Richland County Recreation Commission

Americans with Disabilities Act (ADA) Transition Plan

ADA Transition Plan

Figure 6

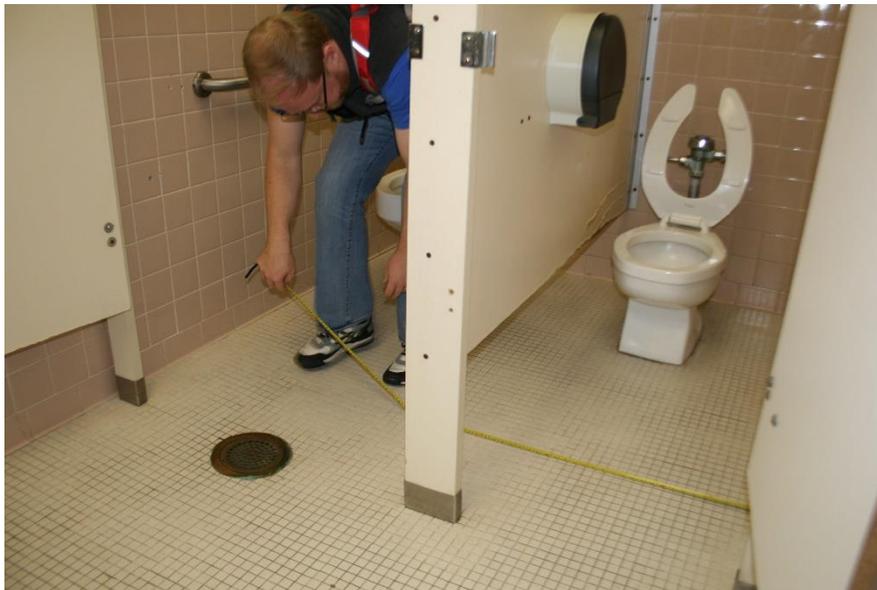
Problems: Both restrooms had two toilet compartments and neither is wheelchair accessible as seen in Figure 6 below.

1. Lower the operable parts of hand dryers and soap dispensers to no higher than 44 inches if over the sink or no more than 48 inches in an open area.
2. Lower the mirrors so that their bottom edge is no higher than 40 inches from the floor when located over sinks or no more than 35 inches from the floor when not located over a sink. Note: if a sink is in the way, another wall may accommodate the mirror.
3. Replace faucet handles with accessible levers or paddles. This can often be done without replacing the entire faucet.
4. Lower door hooks or add door hooks that would fall between 40 and 48 inches from the floor.
5. Remount the urinal so that the brim is no higher than 17 inches from the floor. With this particular urinal, this should be doable without needing to relocate plumbing in the wall.

Figure 8

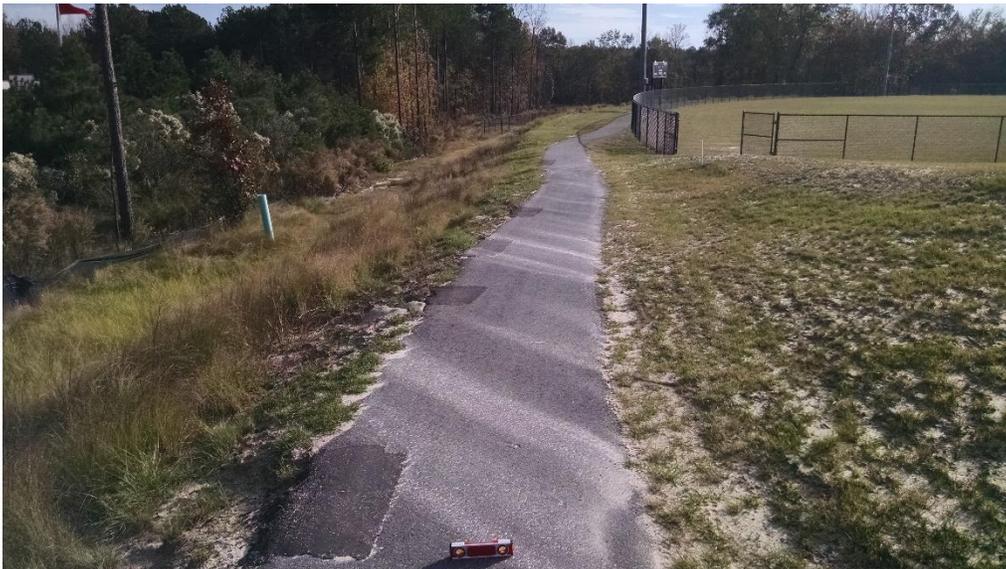
Problems: Two locations on the walking track had cross slope that was beyond the ADA’s limit. One location was near the beginning of the track moving counter clockwise from the main pedestrian entrance to the complex from the parking lot. The other spot is located between the two fields that boarder the school property. One can be seen in Figure 8 below. Both of these sections of the path showed signs of water erosion. It was unclear if the cross slope contributed to the erosion or was caused as a result.

Figure 16 – Blue shaded area signifies ramp from level landing up to sidewalk in two directions

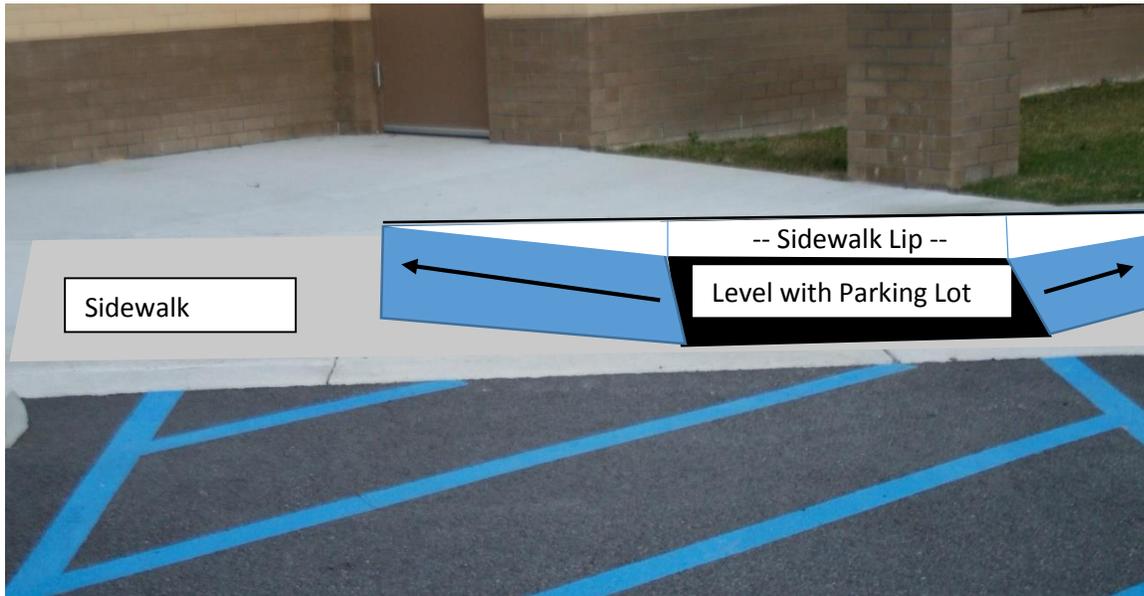
Problem: Curb cut leads to hard/awkward turn as seen in Figure 14 below.

Reconfigure curb cut and sidewalk as seen in Figure 16 Below

Figure 21

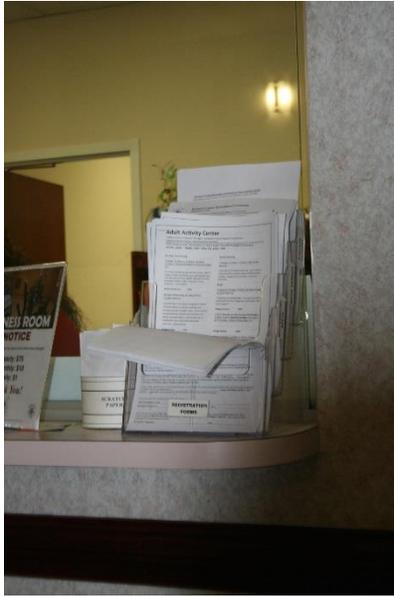
Problems: The brochures toward the back of the brochure holder on the counter are too high to reach from the surface of the counter (Figure 21).

Figure 33

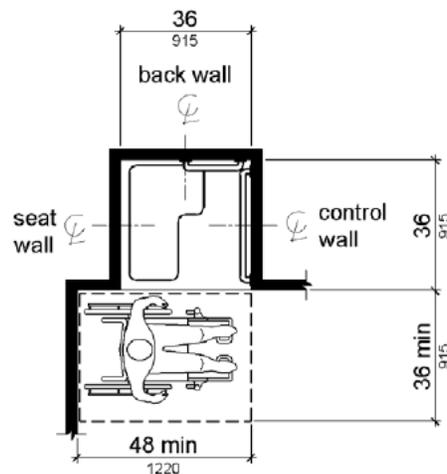
Problems: Accessible path of travel to showers has a 34 inch clearance (Figure 31). The accessible shower stall area is 36.25 inches by 33 inches. The shower control height has a range of 49 to 51 inches. The shower wand is too high and has a twisting knob to control it (Figure 32). The locker door latch design is inaccessible (Figure 33). The sign designating the men's room is mounted on the door and lacks an accessible notice.

1. A redesign of the showers and bathroom space may be required to achieve accessibility. Recommend consultation with a contractor to redistribute space or locate another space for an accessible shower stall.
2. Lower the shower wand height and replace the shower wand so that the controls are compliant with 309.4.

Figure 37

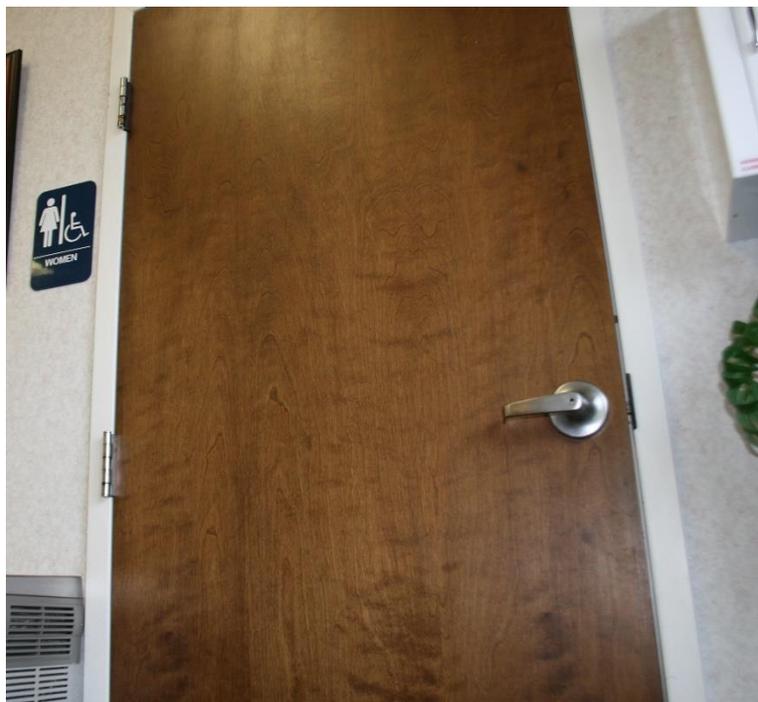
Problems: Sign is on wrong side of the door; soap dispenser is too high – 55.375 inches from floor to operable part (Figure 37).
